INDESIT company

Model type:
AVL65EU

Commercial code:
F029842

Code 093884 - Shock absorber 80 N
Code 093885 - Shock absorber 100 N

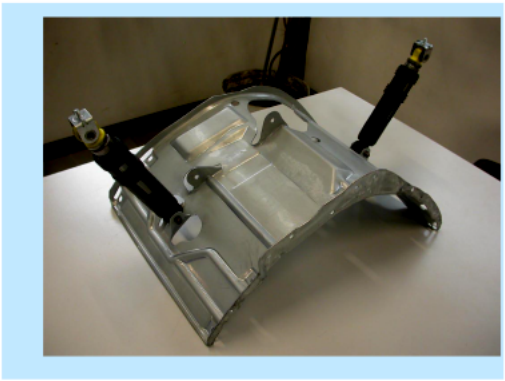
n1040325: New shock absorber fixing system with pin

From serial no. 40427.0001, shock absorbers have been fixed to the tank unit cradle with two 11 mm pins code C00110163 (see fig. 01 and 02 enclosed) in place of the 8 mm screws code 093750 and relevant locking nuts code 030443, on all washing machines and dryers produced in the Comunanza factory.
The items affected by this modification are:
1) The cradles have the same Service code, as they can be used in place of the new ones after widening the shock absorber fixing holes to a diameter of 10 mm.
Code 093848 - Tank unit cradle 46 lt
Code 093878 - Tank unit cradle 40 lt.
2) The new shock absorbers, with fixing bushing having no s/steel spacer, are not managed as they are interchangeable with the premodified items (make sure they are CIMA type, as the managed items), fixed with M8 screws code 093750 and related locking nut code 030443 (see figs. 05 and 06).

To remove the shock absorber from the tank, first extract the pin with a few hammer taps (see fig.03) until it is aligned with the tank bracket and then pull it out with a pair of pliers (see fig. 04).
(To refit the shock absorber use a new pin. Insert the pin until the toroidal edge is aligned with the bracket.)

Fig. n10402231

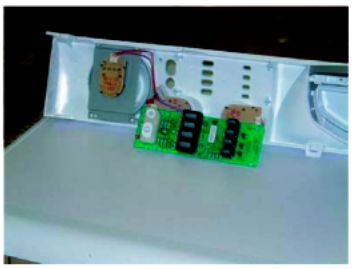
n1040331: Ariston LED restyling

From serial no. 40429.0001, models AVL, AVXL, AVSL, AML have been equipped with a new panel with well holes for the ON/OFF and RESET buttons and flush plastic light diffusers in place of the projecting siliconed ones (see picture n10402231

Fig. n10402232

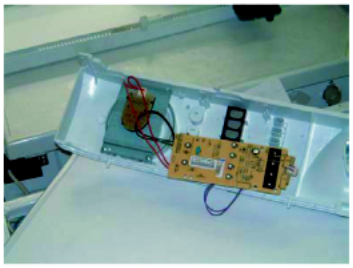
Fig.02). These features determine whether an appliance is modified or premodification.
The modification has also involved the electronic card whose panel and display communication connectors are on the left and not at the back (see picture n10402232 Fig.2).

For both models
C00143338 - LED CARD EVOII AVL /BUILT-IN ARISTON
C00110115 - WHITE BUTTONS ON-OFF/RESET EVOII LED KIT
C00109854 - PANEL WIRING LBE EVOII
C00110055 - SILICONED BUTTONS AVL-AVSL
C00110059 - PANEL WIRING -DISPLAY 240000848B2.
C00111227 - WIRING MAIN - DISPLAY 24000084804B1 (POLARIZED).
The new parts are only interchangeable with the pre-modification ones if used altogether. They are not individually interchangeable.

Fig . 001

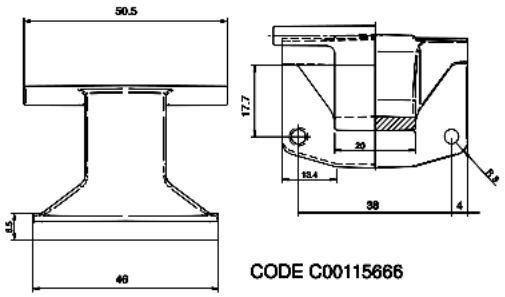
n1040349: Introduction of 150° Zamac hinge on Ariston 46 models.

From serial no. 50207.0001, all Ariston models produced in the Teverola factory (see table 001 attached) with industrial code (given on the rating plate) starting with 46, have been equipped with a Zamac hinge with 150° opening angle, code C00115666 (see Fig.001).
This modification has involved the introduction of the following items:

Code C00115670 - Complete door EVOII 150° white 27 with standard glass;
Code C00115674 - Complete door EVOII 150° white 27 with long glass;
Code C00115667 - EVOII body for 150° hinge white 27;
